Access Compliance Report

Public Rights-of-Way

(Curb Ramps)

Intersection ID: 10035551	Main Street: REA_RD	Cross Street: N/A	Location: SE
ADA ID: 79E731378685	Ramp Type: PerpDiag	Initial Pass/Fail: Fail	Overall Compliance: No
Severity Score: 21.25			
Codes/Mitigation Info/Possible Solution		Field Measurements/Component Compliance

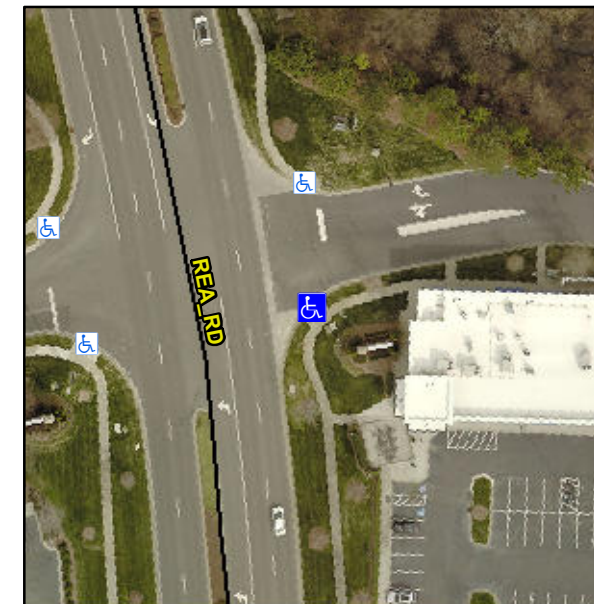
Not Found, R304.5.1, R304.2.2

Compliance	Description	Data	Compliance	Description	Data
N/A	Ramp Length (in)	72.0	No	Ramp Slope (%)	9.2
No	Ramp Width (in)	46.5	Yes	Ramp XSlope (%)	1.6
N/A	Flare Type LT	N/A	N/A	Flare Type RT	N/A
N/A	Flare Slope LT (%)	N/A	N/A	Flare Slope RT (%)	N/A
N/A	Flare Traversable LT?	N/A	N/A	Flare Traversable RT?	N/A
N/A	Landing Length (in)	N/A	N/A	DWS Provided?	N/A
N/A	Landing Width (in)	N/A	N/A	DWS Contrast?	N/A
N/A	Landing Slope (%)	N/A	N/A	DWS Length (in)	N/A
N/A	Landing X Slope (%)	N/A	N/A	DWS Full Width?	N/A
N/A	Landing Curb? (Y/N)	N/A	N/A	DWS Offset (in)	N/A
N/A	Shared Landing?	N/A			
N/A	Gutter Ponding?	N/A	N/A	Gutter Slope (%)	N/A
N/A	Gutter Lip Ht (in)	N/A	N/A	Gutter X Slope (%)	N/A
N/A	Painted X Walk1?	No	N/A	Painted X Walk2?	No
	X Walk 1 Direction	To N		X Walk 2 Direction	To W
N/A	X Walk 1 Width (in)	N/A	N/A	X Walk 2 Width (in)	N/A
	X Walk 1 Slope (%)	0.4		X Walk 2 Slope (%)	0.8
	X Walk 1 X Slope (%)	2.2		X Walk 2 X Slope (%)	1.3

Remove & Replace Curb Ramp With Two New Directional Ramps or Equivalent.
